STAFF RECOMMENDATION
1322 6th Avenue North
August 16, 2017

Application: New construction – outbuilding; Appurtenances – exterior lighting

District: Germantown Historic Preservation Zoning Overlay

Applicant: Patrick Bales, Architect

COURTYARD PLAN
SCALE: 1/4"=1'-0"

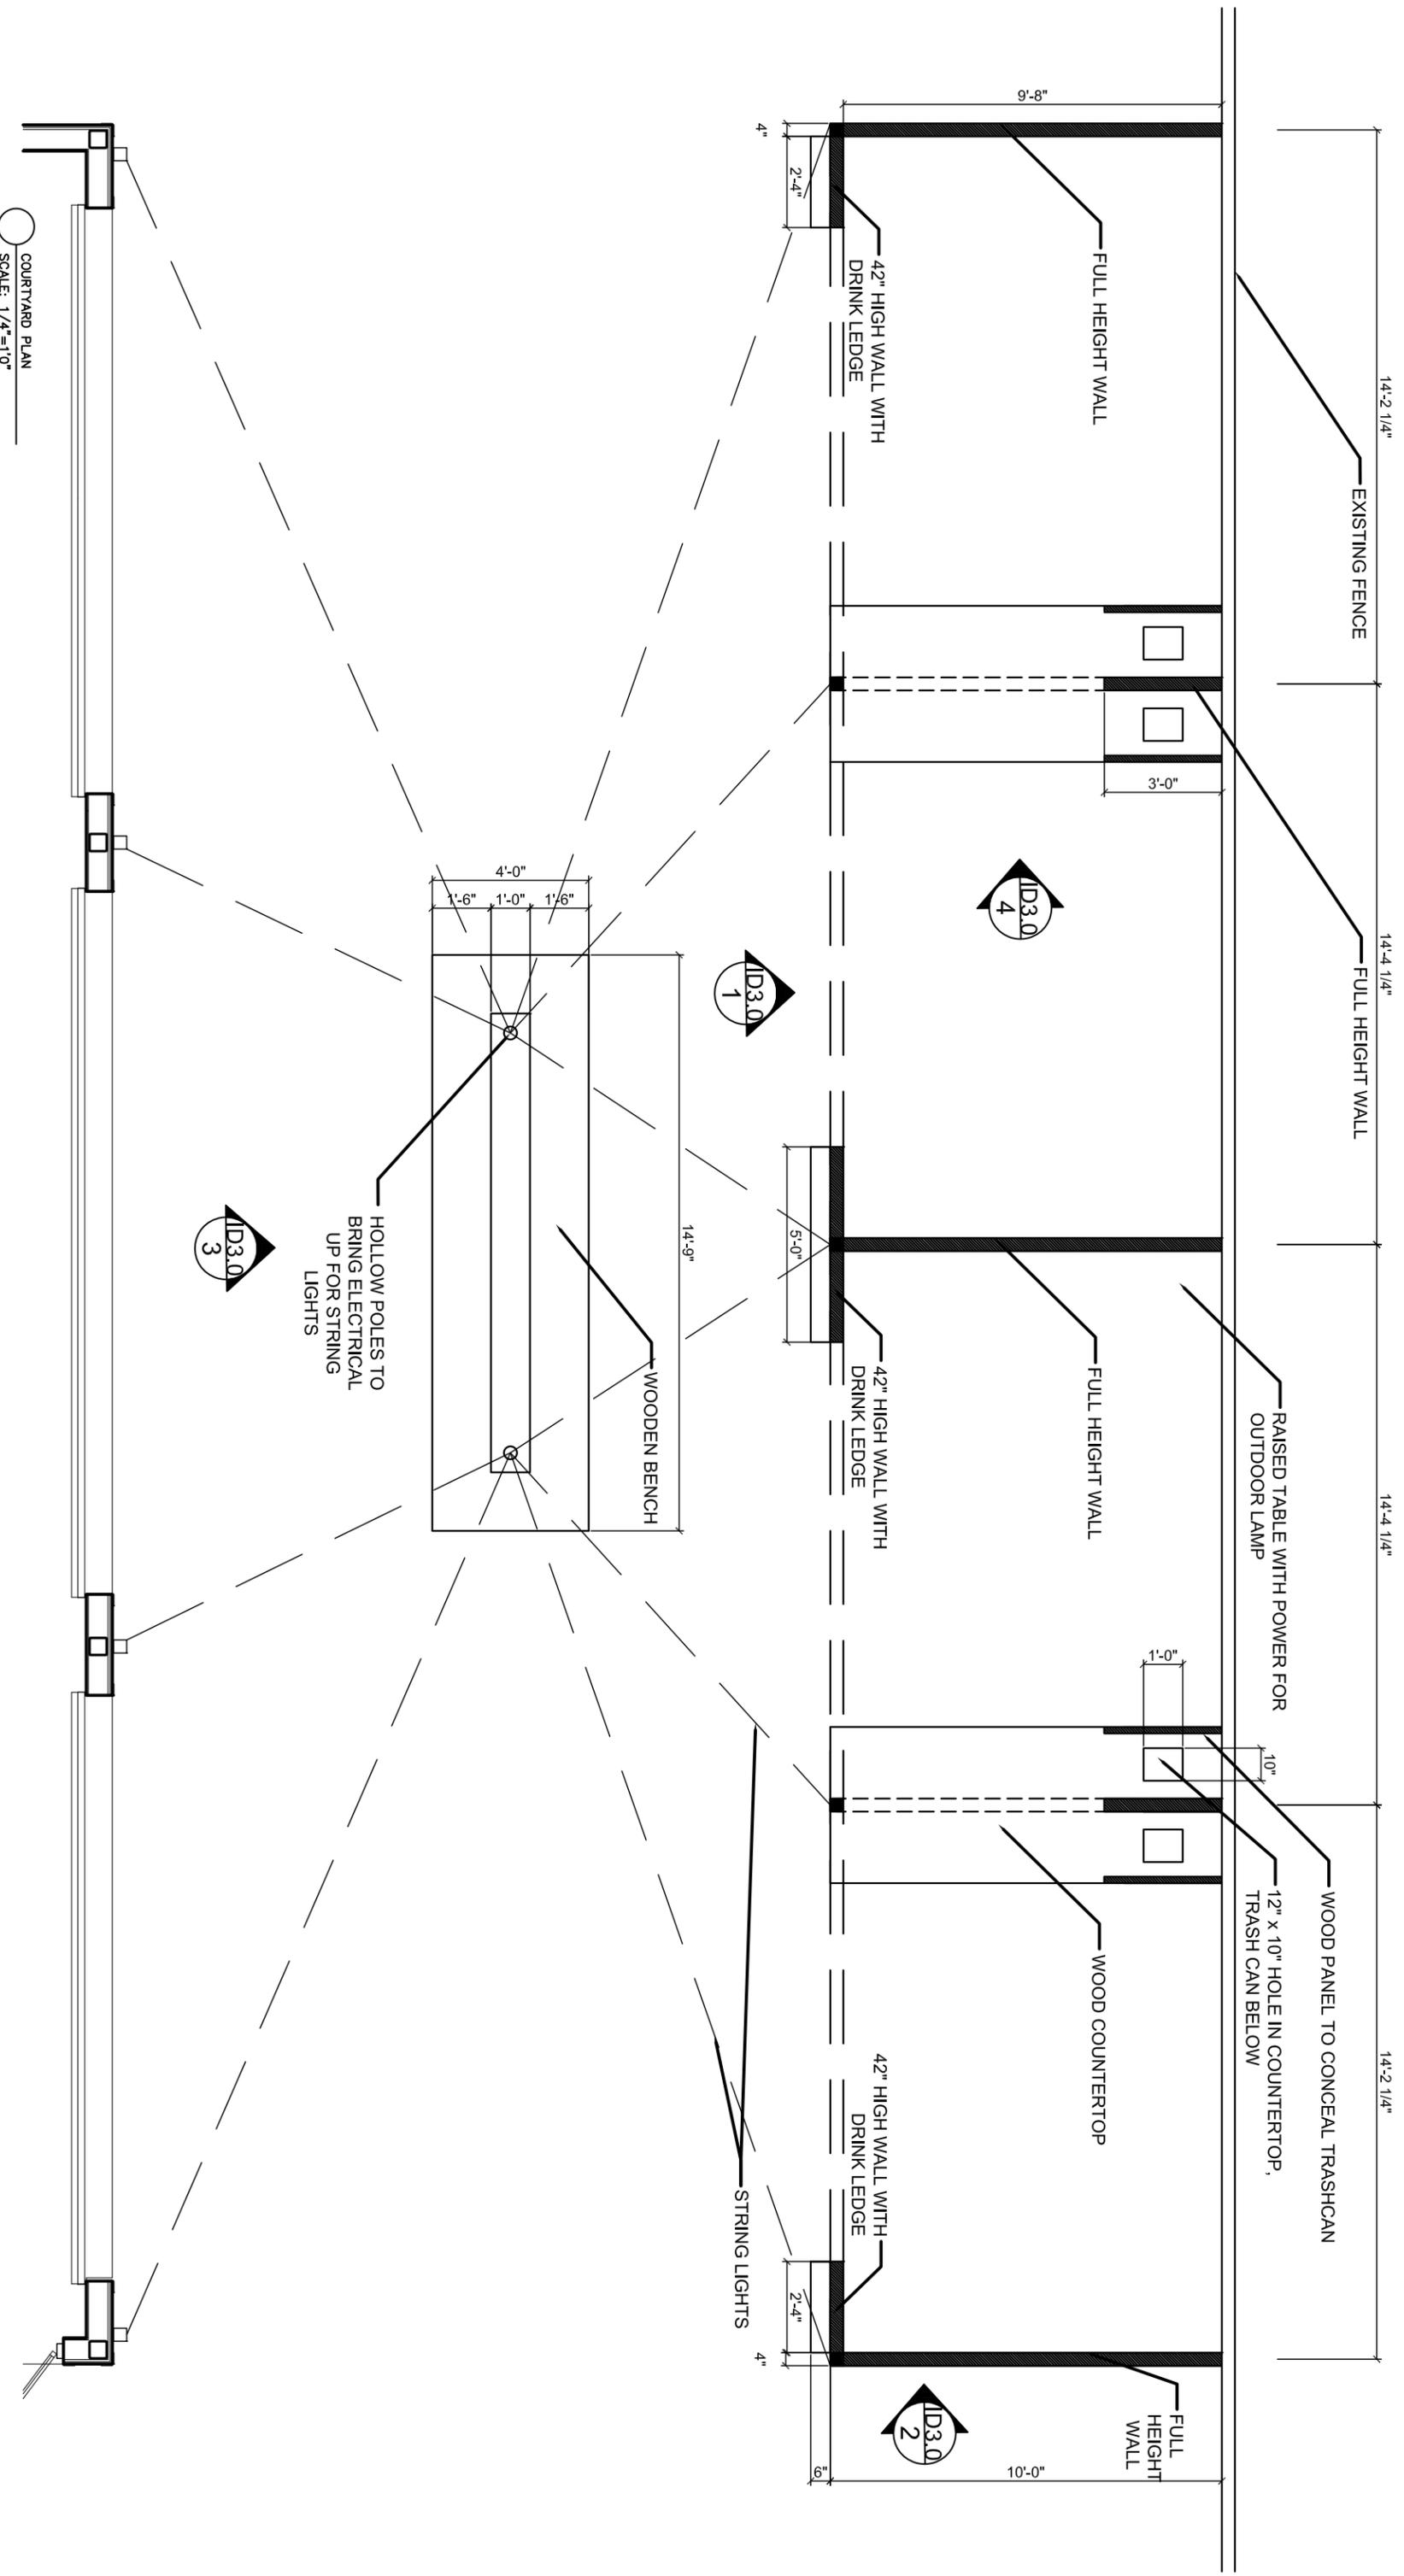
The outbuilding will be located at the rear of the courtyard with eighteen feet (18') of separation between it and the principal building. Staff finds the location to be appropriate and to meet section 2.9.2 of the design guidelines.

The proposal includes a permanent planter with attached bench seating located between the proposed outbuilding and the existing building. The planter will be four feet (4') deep and fifteen feet (15') wide, and four feet (4') tall, with a sign-above it. The planter and sign will be wood, and will be located in the center of the courtyard and will not be

String lighting will be hung across the courtyard from the planter sign to the principal building and the new outbuilding. Staff is concerned that this type of lighting does not meet section 5.4.2 which calls for lighting to be compatible in style, size, scale and material with the character of the structure and neighborhood. (In addition, the lighting may not meet code section 17.28.100 which does not allow for “excessive rope lighting,” which includes “strand lighting, lite ropes, flexible impact lighting, tubular lighting, string lighting, or other similar forms of illumination.”) Staff recommends bollard type lighting for the rear patio which will meet section 5.4.2, section 5.4.3 because it does not spill into adjacent properties and section 5.4.4 because it is ground mounted and screened from public view.

Recommendation Summary: Staff recommends approval of the outbuilding, planting box and signage with the condition that bollard lighting or another type of ground lighting be used rather than string lighting, finding the proposal to meet the applicable design guidelines for the Germantown Historic Preservation Zoning Overlay.

1 ELEVATION - CABANA FRONT VIEW
SCALE: 1/4"=1'0"

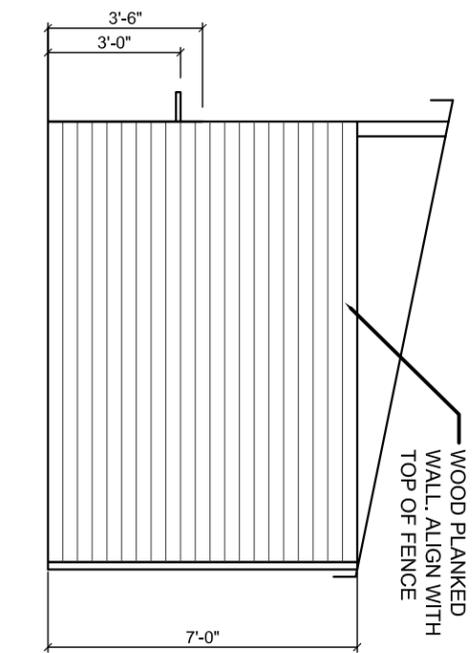
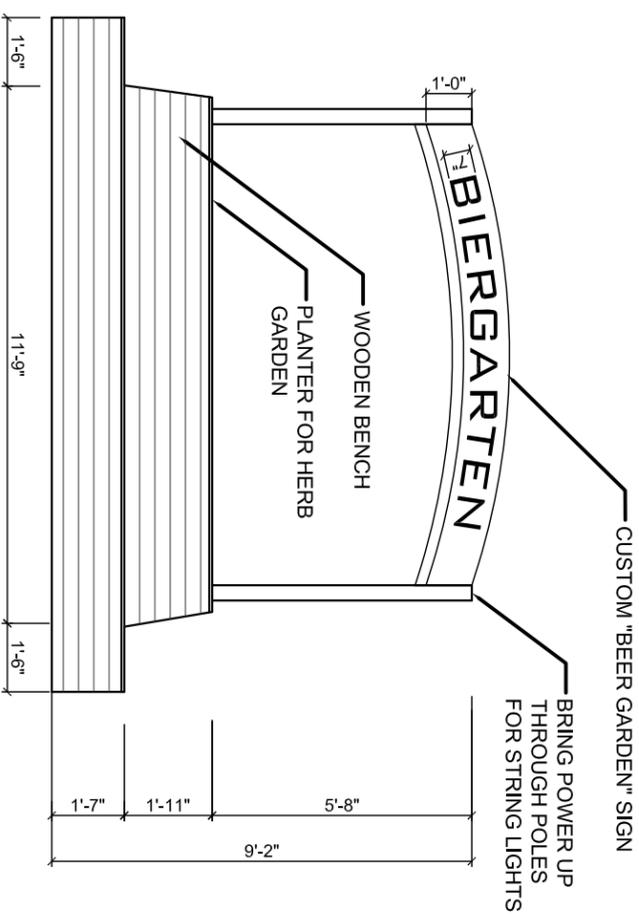
The new building will be one story, matching the width of the principal building at fifty-seven feet (57') with a depth of ten feet (10'). Staff finds the area of the five hundred, seventy square foot (570 sq. ft.) outbuilding to be appropriate. The maximum height of the building will be nine feet, two inches (9'-2") which is also appropriate. Staff finds the scale of the proposed outbuilding to meet section 2.9.5 of the design guidelines for outbuildings.

The building will resemble a pole shed with wooden posts, wood flush-plank side walls, attaching to the existing wooden fence so that it serves as the rear wall. There is no front wall. The shed roof of the building will be canvas. Canvas is not a typical roofing material for outbuildings, however the roof will be a shed sloping to the rear therefore it will not be visible from the public right-of-way. Staff finds the materials of the proposed outbuilding to be appropriate and to meet section 2.9.1 of the design guidelines.

The roof of the outbuilding will be a shed sloping down to the rear, with a height of nine feet (9'-2") at the front and seven feet (7') at the rear. Staff finds this to be appropriate for outbuildings and to meet section 2.9.1 of the design guidelines.

3 ELEVATION - OUTDOOR BENCH
SCALE: 1/4"=1'0"

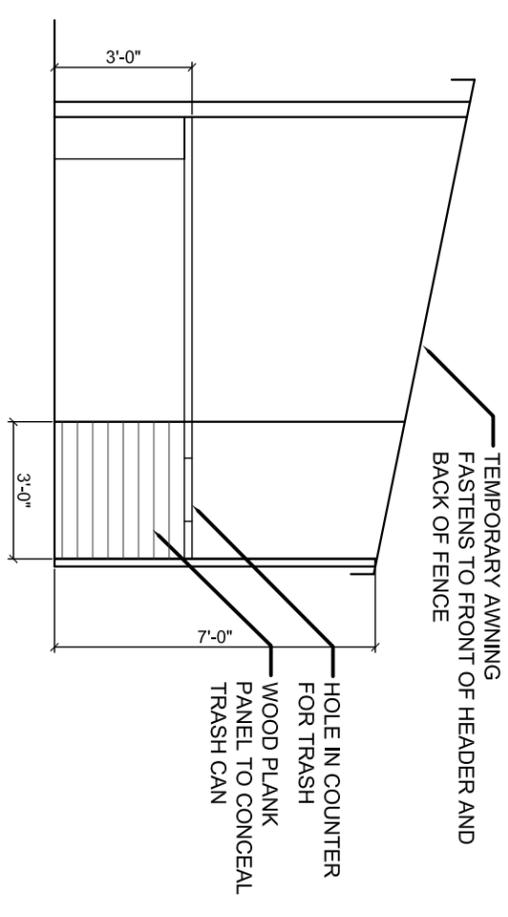
The sign will be located in the planter box, described previously, and so is also not visible from the public right-of-way. The sign will not have internal or directed illumination, but will be lit indirectly by lighting described below. Staff considered the signage “directional signage” since it does not display the name of the business and is not located towards either street frontages and so did not review it in terms of appropriate number of signs or sign location. It does not meet the requirements for “signage not permitted” and is appropriate in terms of lighting and materials. Staff finds the feature and signage to meet sections. 8.2
